Addendum 47: Regulation No. 48

Revision 6 – Amendment 5

05 series of amendments - Date of entry into force: 30 January 2011

Uniform provisions concerning the approval of vehicles with regard to the installation of lighting and light-signalling devices

Model A

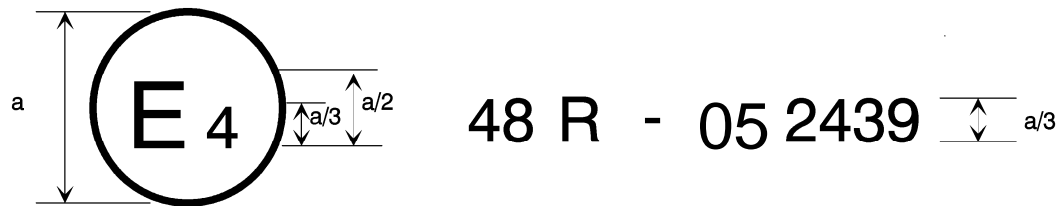
Annex 2, amend to read:

The above approval mark affixed to a vehicle shows that the vehicle type concerned has, with regard to the installation of lighting and light-signalling devices, been approved in the Netherlands (E4) pursuant to Regulation No. 48 as amended by the 05 series of amendments. The approval number indicates that the approval was granted in accordance with the requirements of Regulation No. 48 as amended by the 05 series of amendments.

Model B

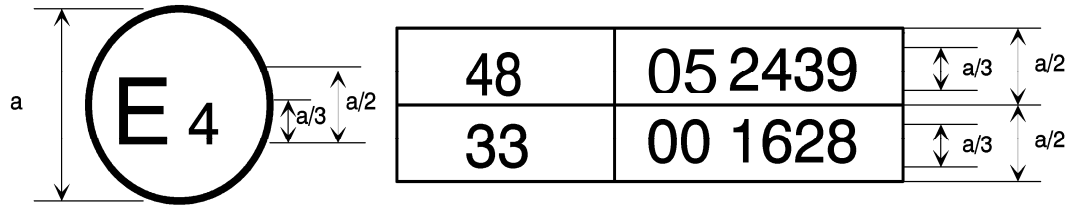
The above approval mark affixed to a vehicle shows that the vehicle type concerned has been approved in the Netherlands (E4) pursuant to Regulation No. 48 as amended by the 05 series of amendments and Regulation No. 33¹. The approval number indicates that, at the dates when the respective approvals were given, Regulation No. 48 was amended by the 05 series of amendments and Regulation No. 33 was still in its original form.
